DEVIATION REQUEST AND DECISION FORM

Project Name : Mayberry Phase 1
 Schedule No.(s) : PUDSP219, including SF1825 (Filing 1), VR2113 (Filing 1A), VR2322 (Filing 1B), SF2219 (Filing 3)
 Legal Description : NE1/4 of Sect 15 & N1/2 of Sect 14, Township 14 S, Range 63 W of 6th P.M., El Paso County, Colorado

A deviation from the standards of or in Section **2.4.1.E-1** of the Engineering Criteria Manual (ECM) is requested.

2.4.1.E-1: Roadway Access Design Criteria – Residential Access Width (i.e. width of driveway)

Exhibit 'A'

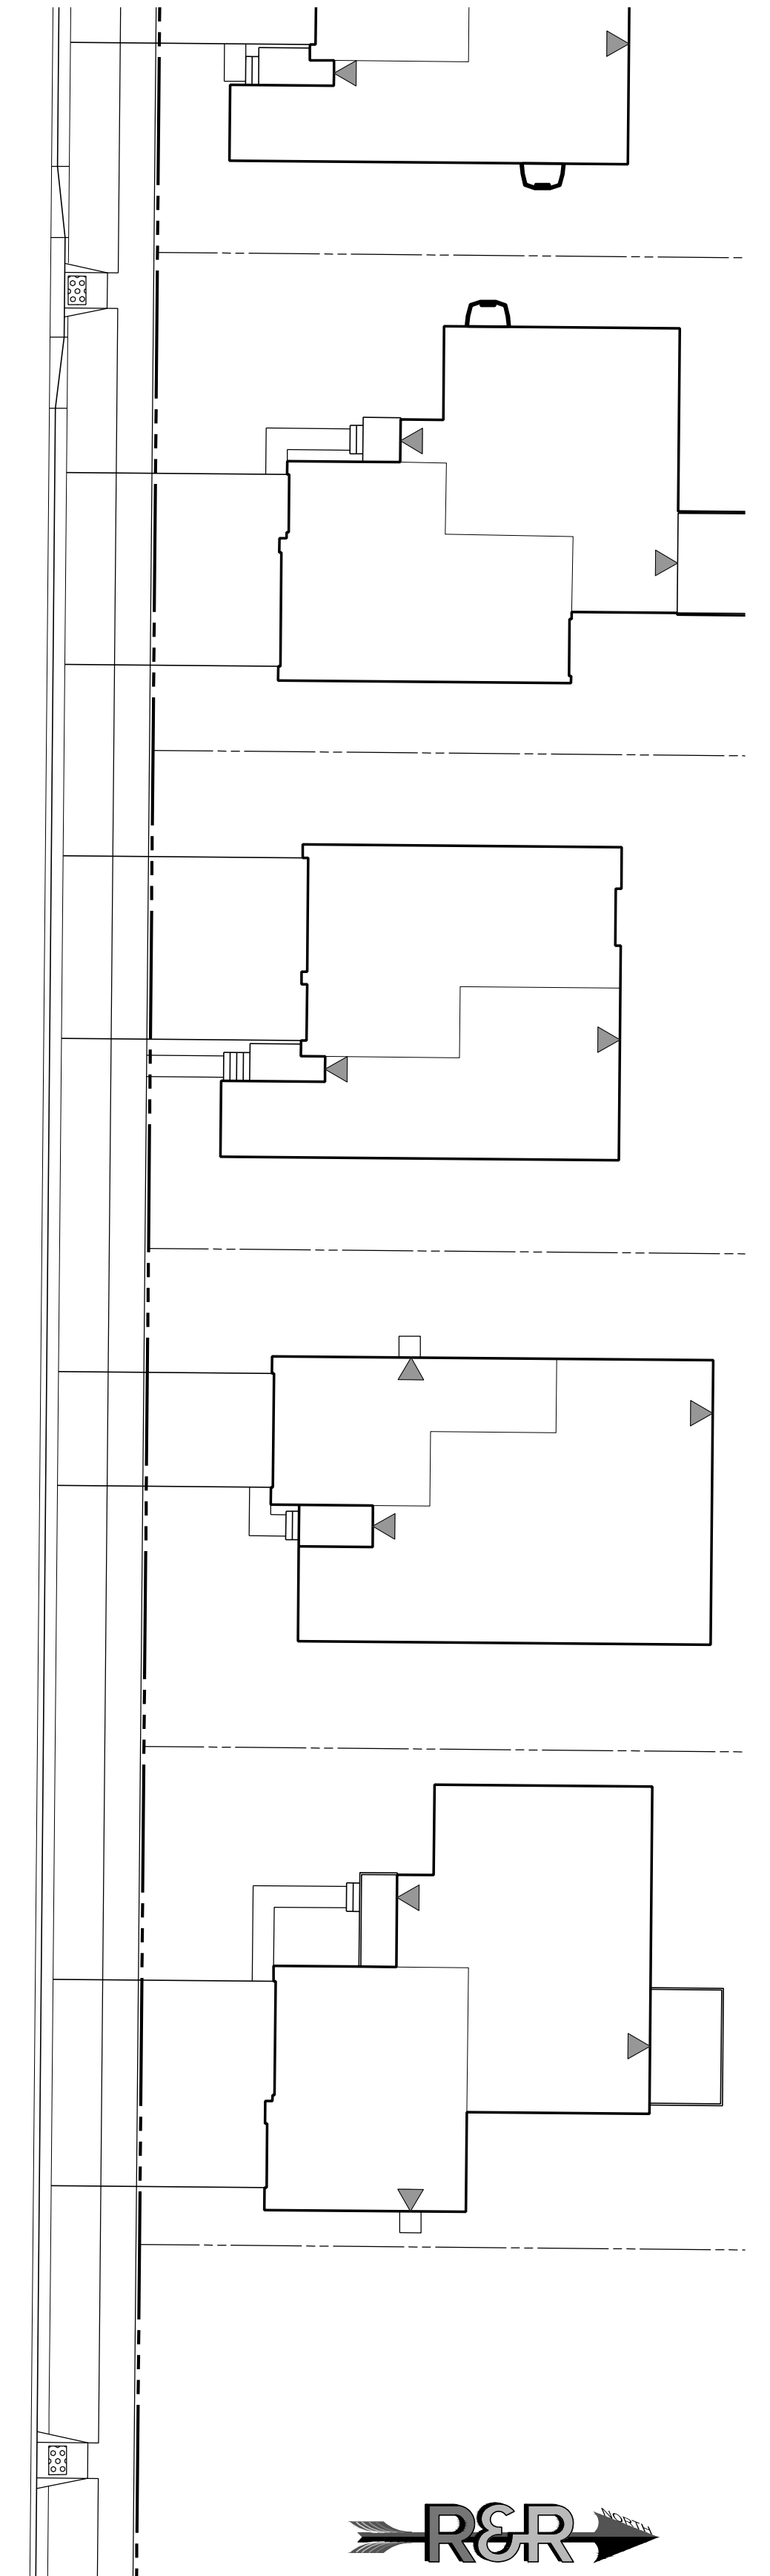
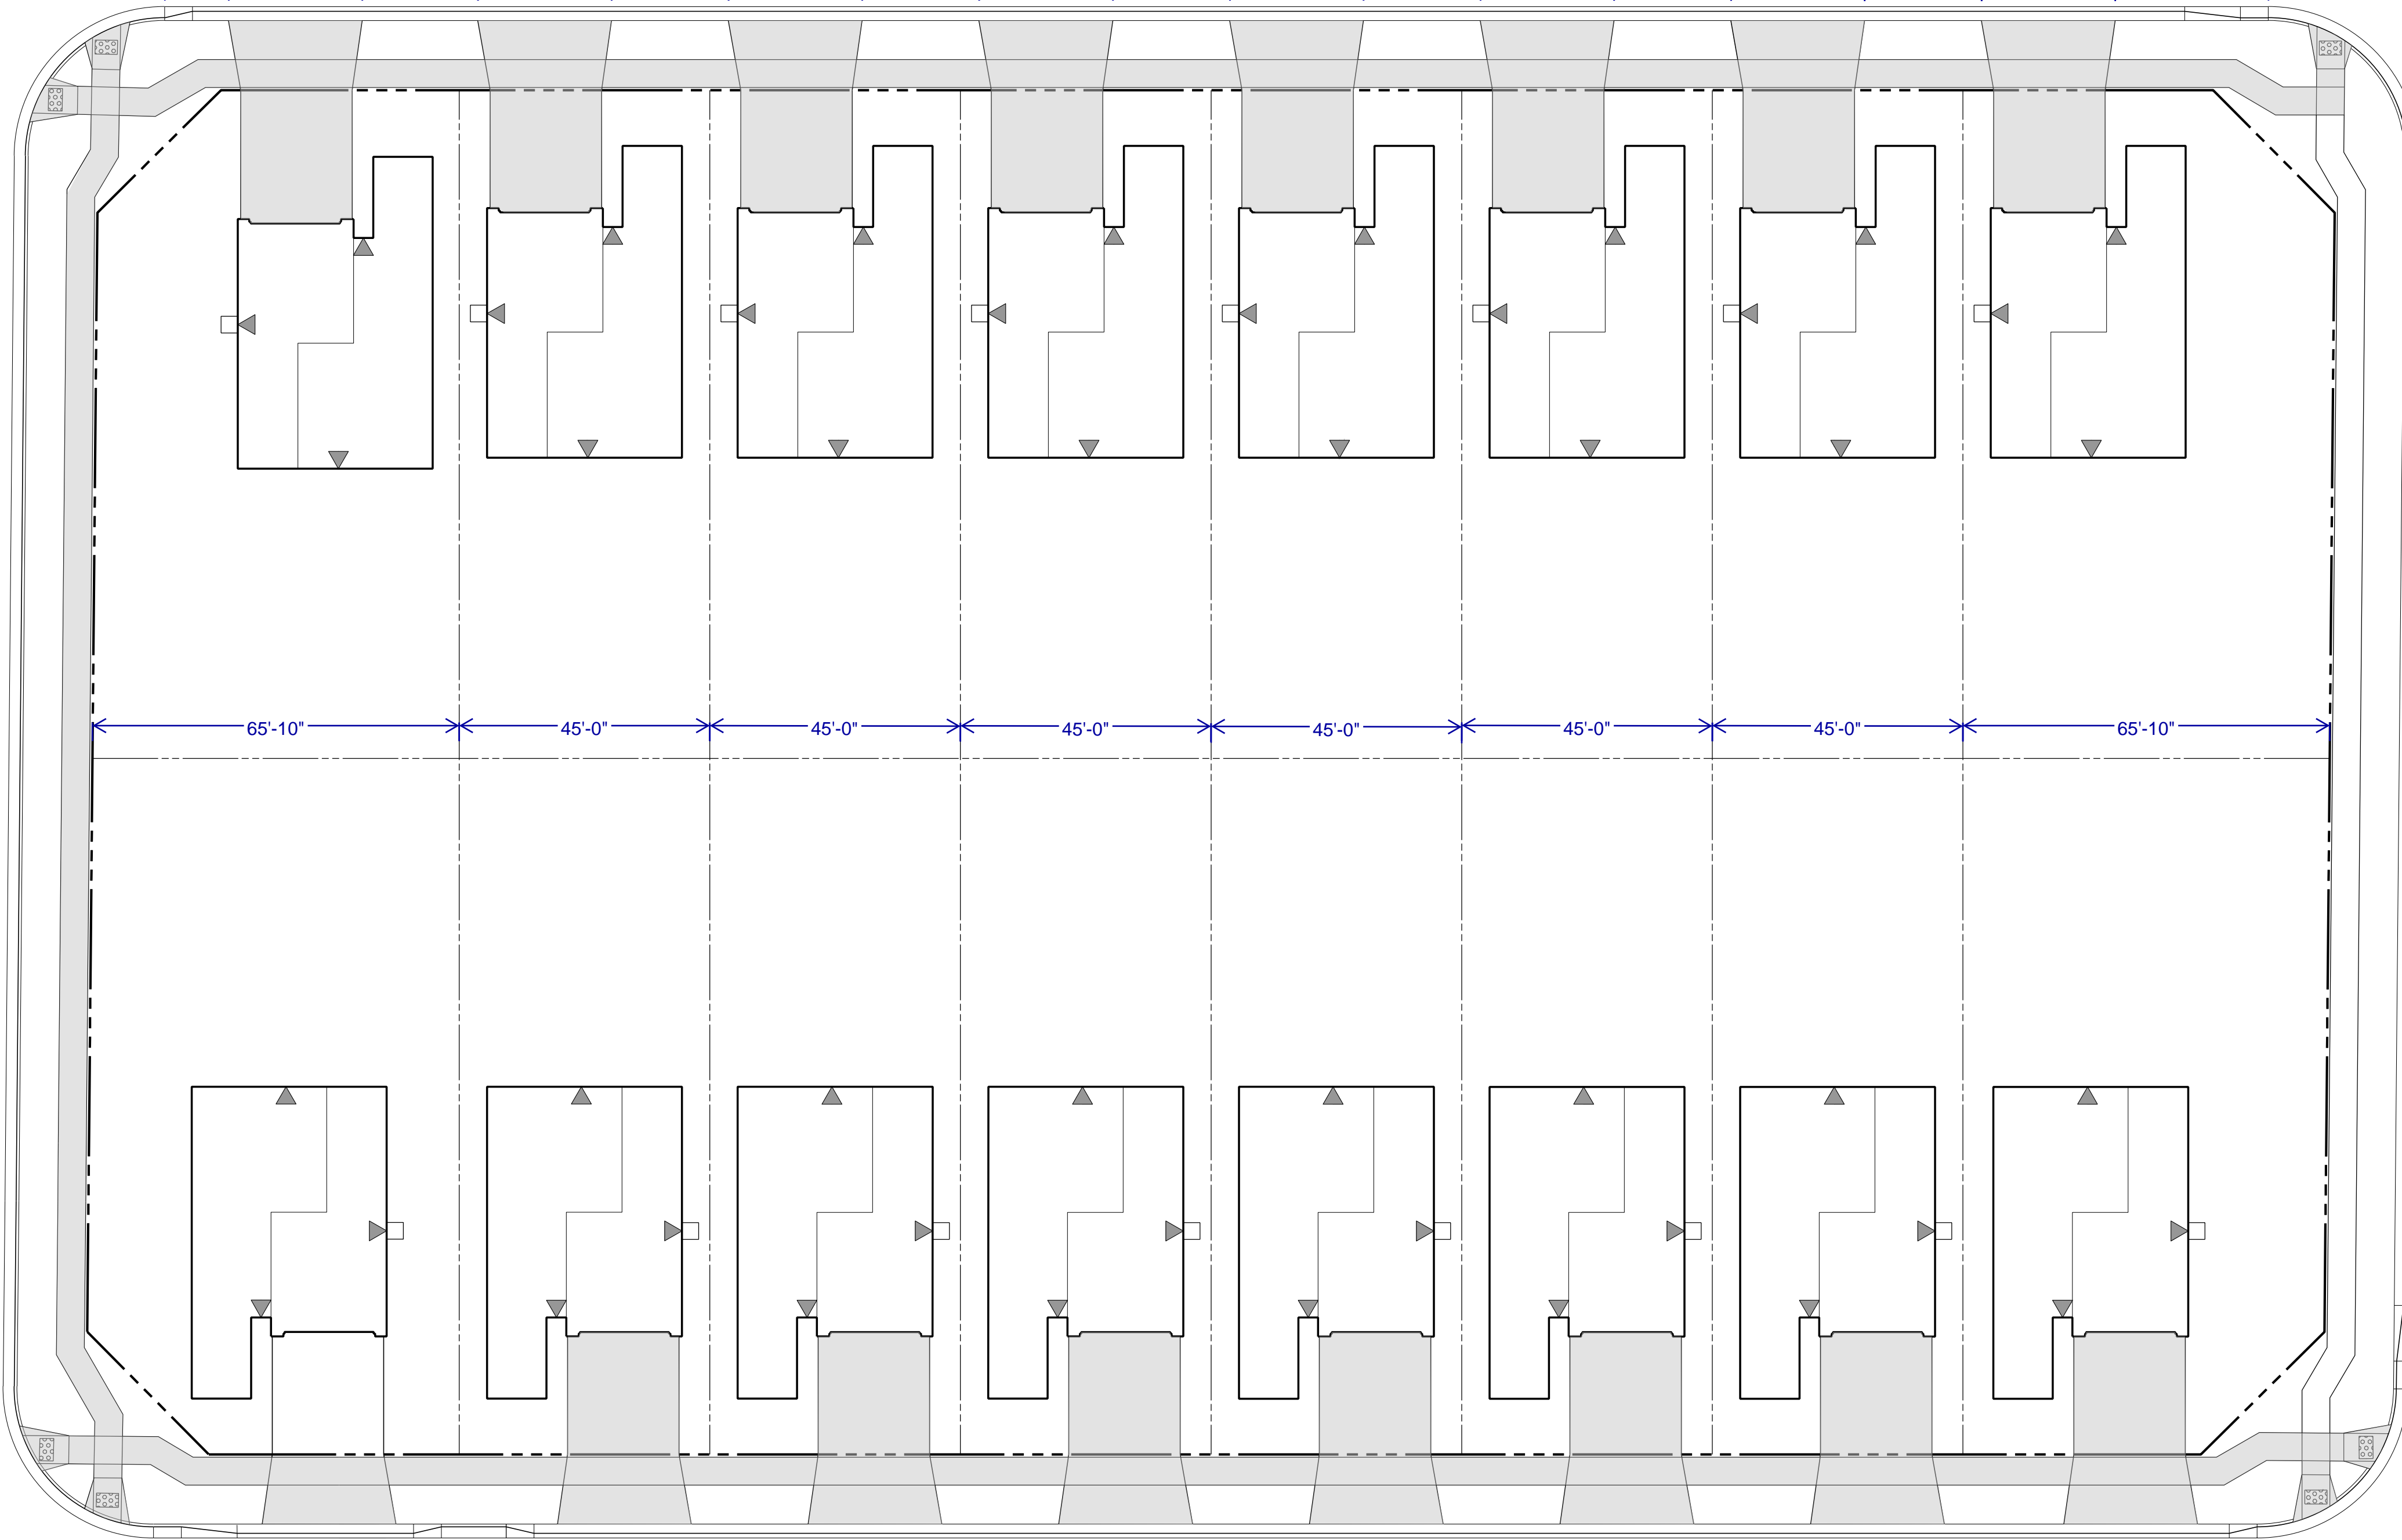
The above proposed alternative criteria meet or exceed the per lot minimum on-street curb length and/or pedestrian safe zone resulting from a standard 24-foot driveway located on lots equal to or less than 45-feet in width. See attached worksheet comparing the minimum lot widths per home plan/garage configuration currently offered by Mayberry (Exhibit 'A').

Exhibit 'A' identifies:

- 26 plan type options
- Minimum Lot Width – lots must be at least this width in order for plan type to be sited
- Garage Configuration – opening width(s) and size(s) of each garage door offered per plan type (includes intermediate wall length)

- Driveway Width Limitation 1 – calculates driveway width 2' wider each side than out-to-out opening of garage doors
- Driveway Width Limitation 2 – calculates max driveway width equal to 50% of lot width

- Narrowest dimension of Limitation 1 or 2 controls
- Deviation – controlling width in excess of 24' per proposed plan type driveway
- Min. LS Buffer to Lot Line – all driveways are set a minimum of 5' from property line, this space is to be landscaped

- LS Buffer to Opposite Lot Line – remaining lot frontage after subtracting proposed driveway plus 5' side yard buffer
- On-street Curb Length – Total curb length remaining per lot beyond driveway frontage

EXHIBIT 'B'
Example ECM Compliant Driveway
Block Layout

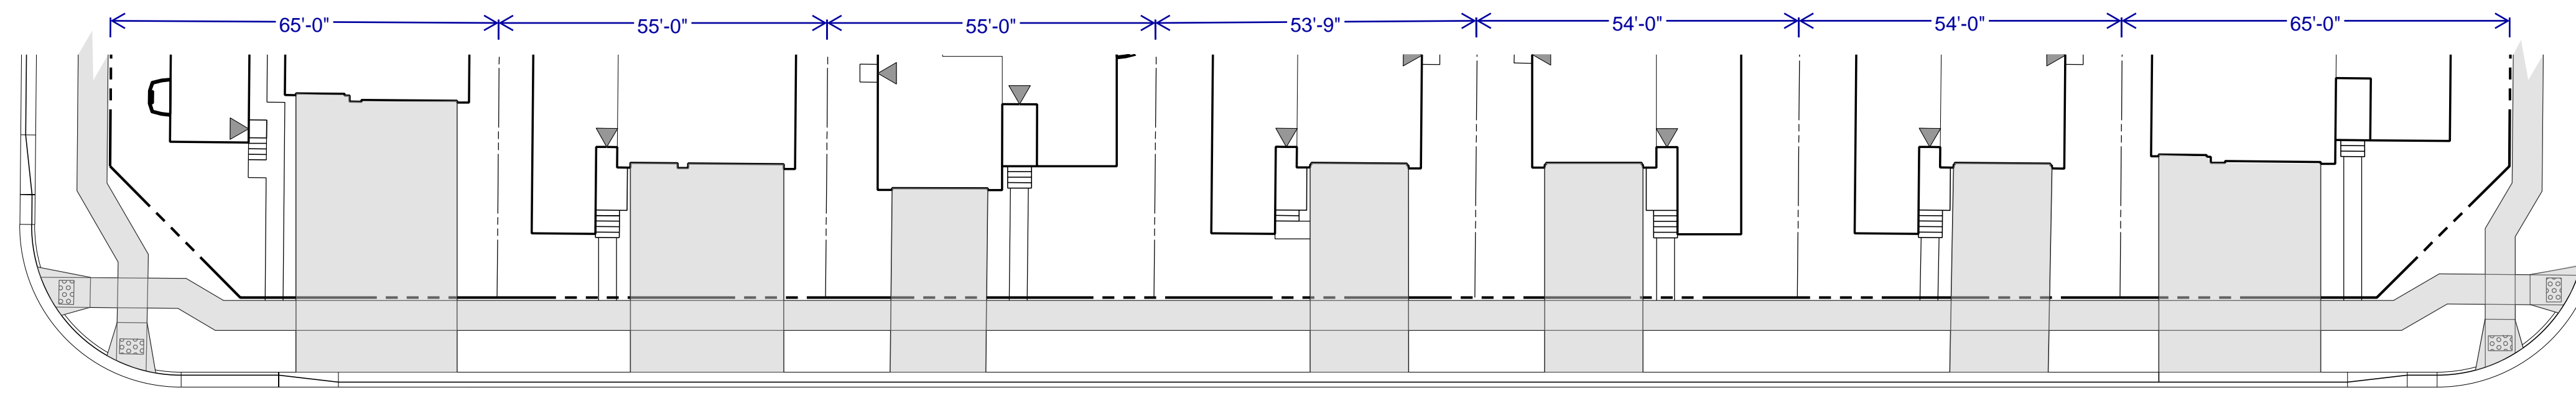
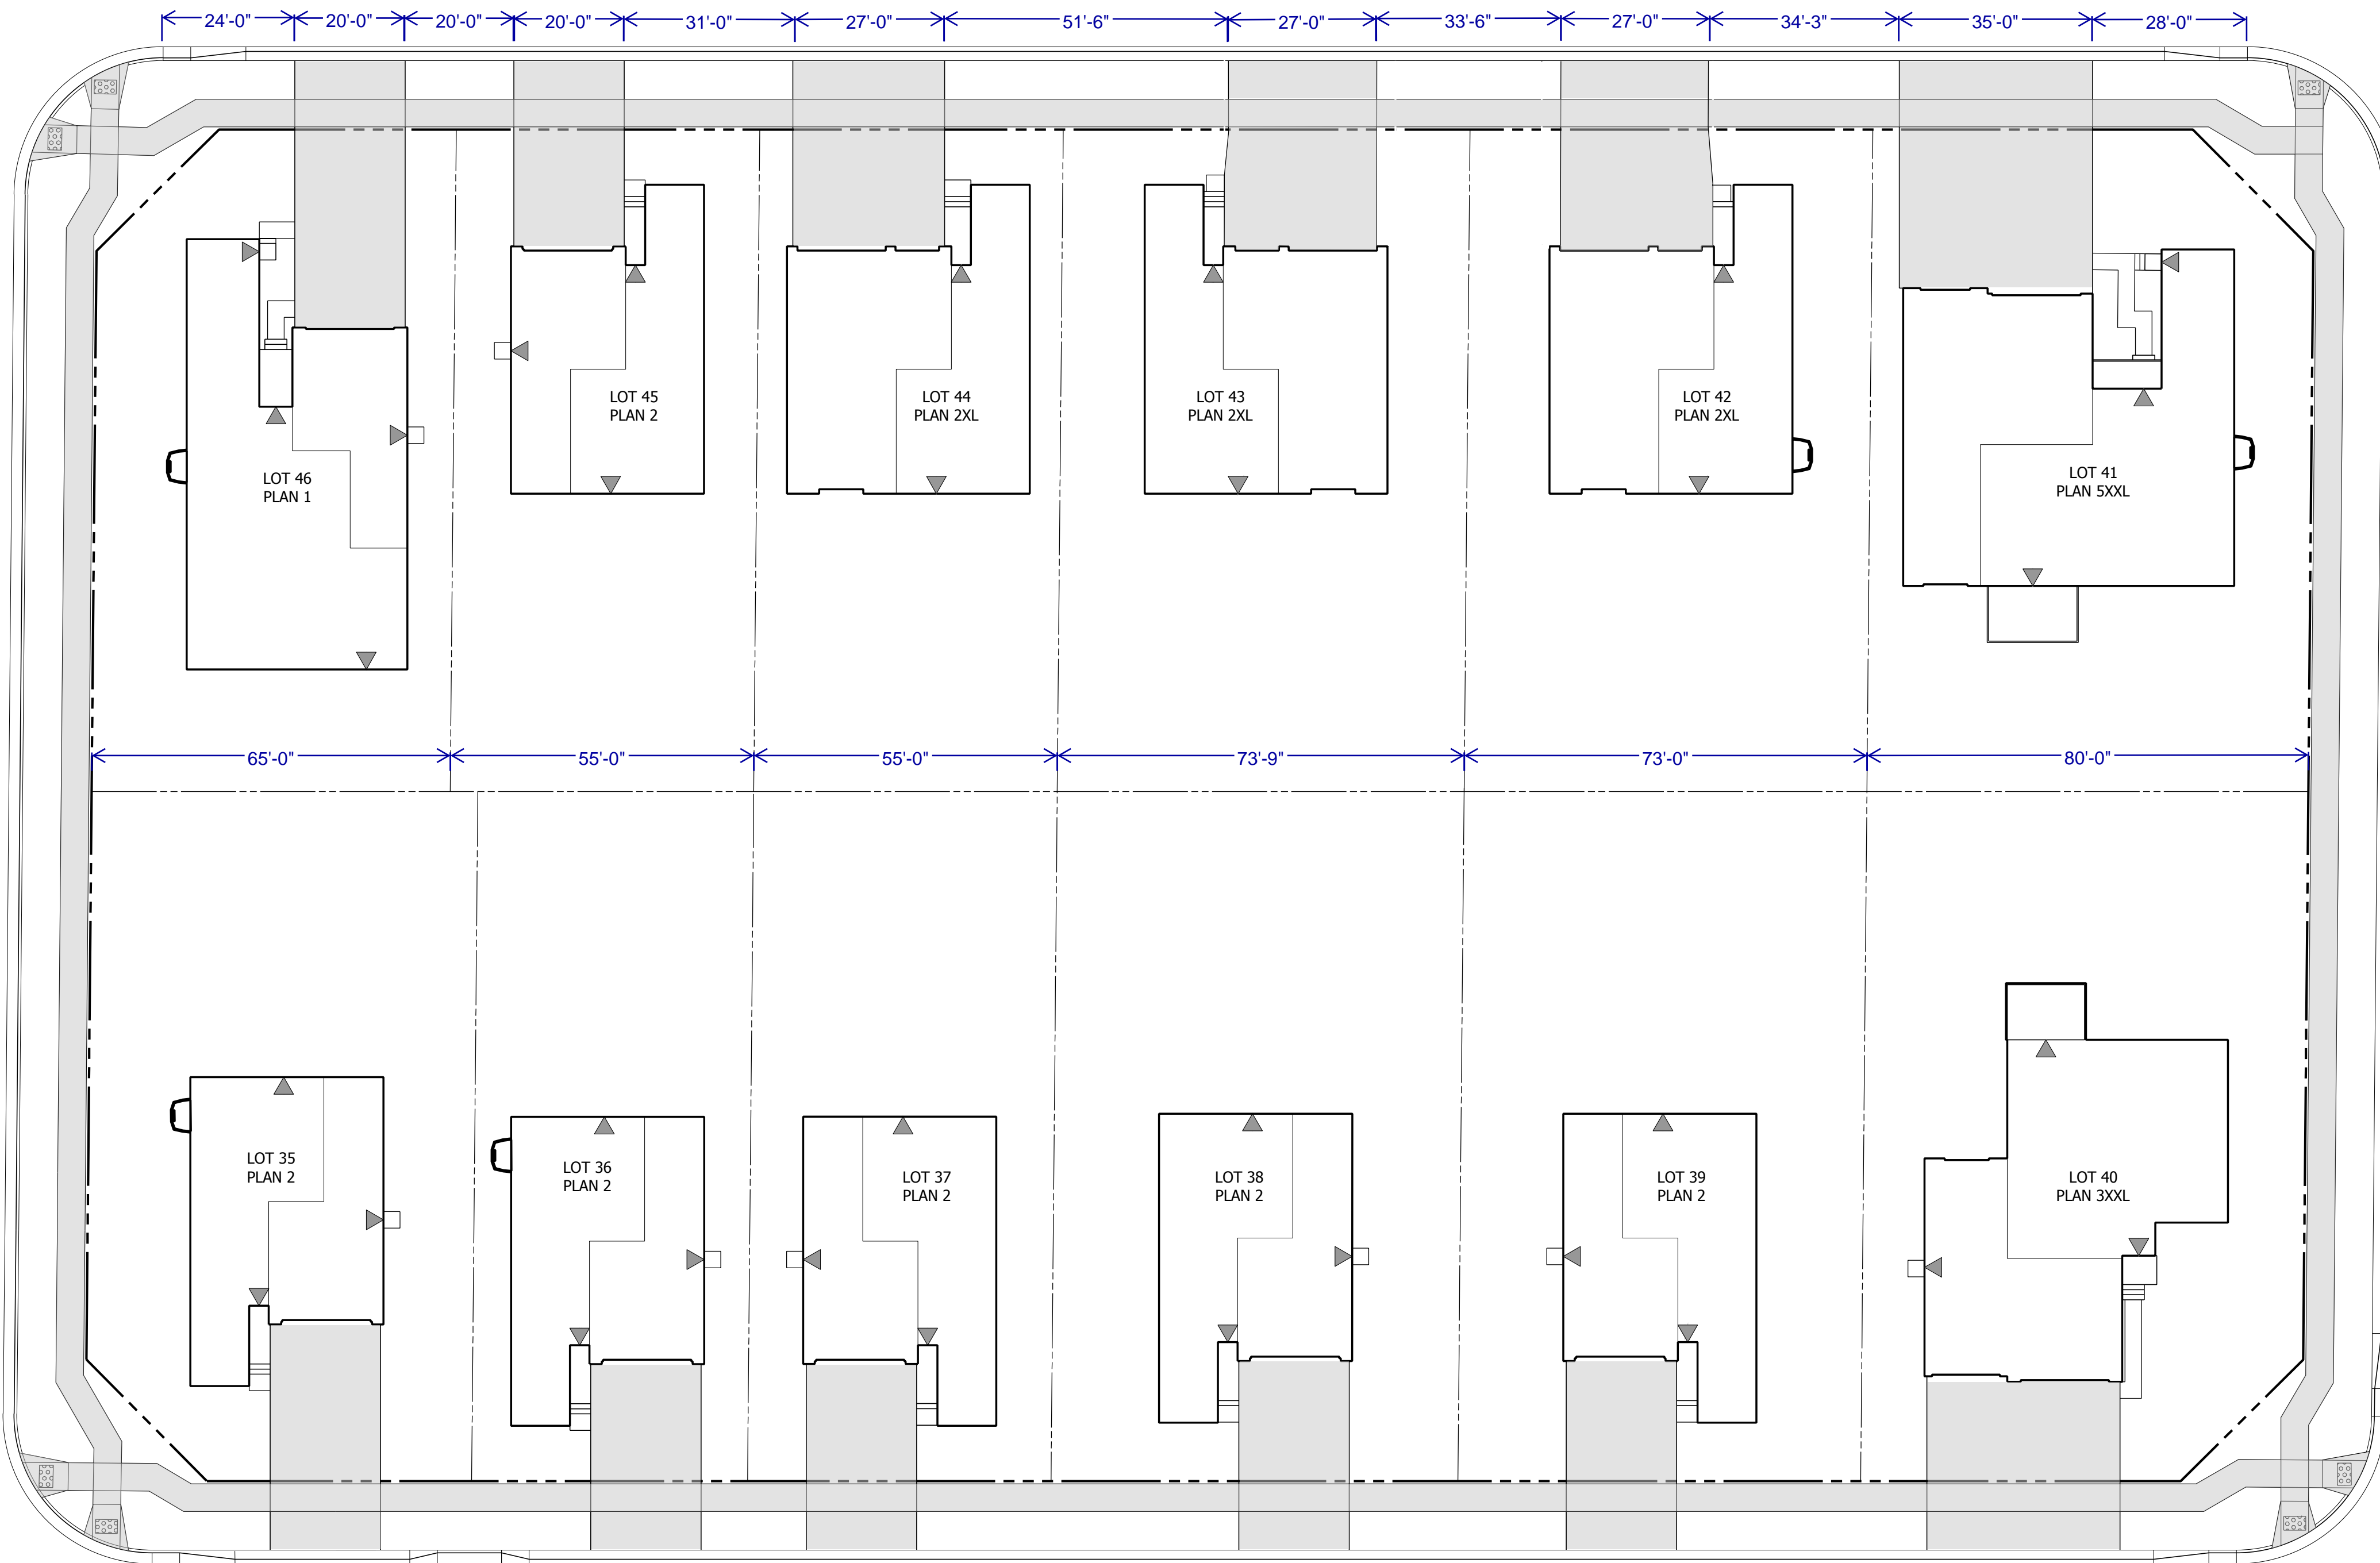
The Exhibit 'B' provides a schematic illustration of lots 45' in width with ECM maximum 24' wide driveways, all evenly spaced, while Exhibit 'C' illustrates a sample block layout of actual Mayberry homes designed with driveway layouts conforming to the criteria requested through this deviation request. These exhibits demonstrate that this deviation meets the design intent and purpose of the ECM standards.
